THE  
UNIVERSITY  
OF UTAH

The enclosed materials are submitted in support of the University of Utah's application for renewal of its TRIGA Nuclear Reactor Operating License, R-126, Docket No. 50-407.

## UNIVERSITY OF UTAH TRIGA REACTOR (UUTR)

D<sub>2</sub>O Filled Central Irradiation Facility

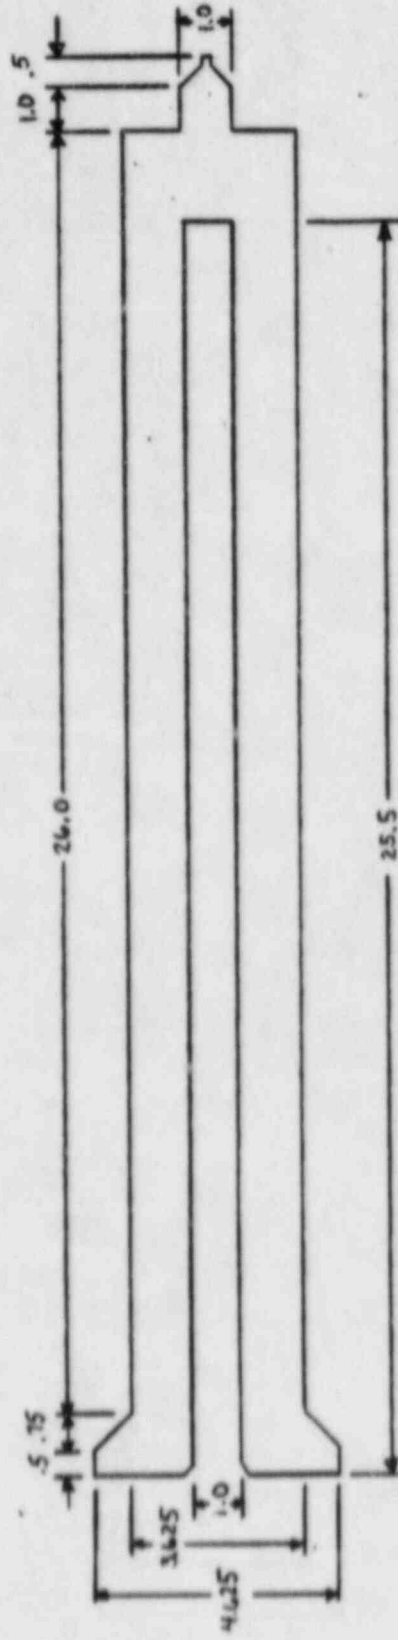
36. Describe the central irradiation facility of the reactor and the different types of irradiators now in use at this facility. Provide the dimensions and schematic drawings of these facilities.

There are three different irradiators used in the TRIGA core central irradiator location. Attached drawings provide dimensioned drawings of these irradiators. Two are filled with  $D_2O$  (one has a 7 hole concentric row for neutron sample irradiation and the other has a single central hole surrounded by  $D_2O$ ) and a third irradiator is air filled to provide a fast neutron spectrum for the sample. The reactivity difference between the  $D_2O$  filled irradiator and the air filled irradiator has been measured at  $\rho = 0.62$ . For  $H_2O$  in the irradiator this reactivity difference is less than  $\rho = 0.15$ .
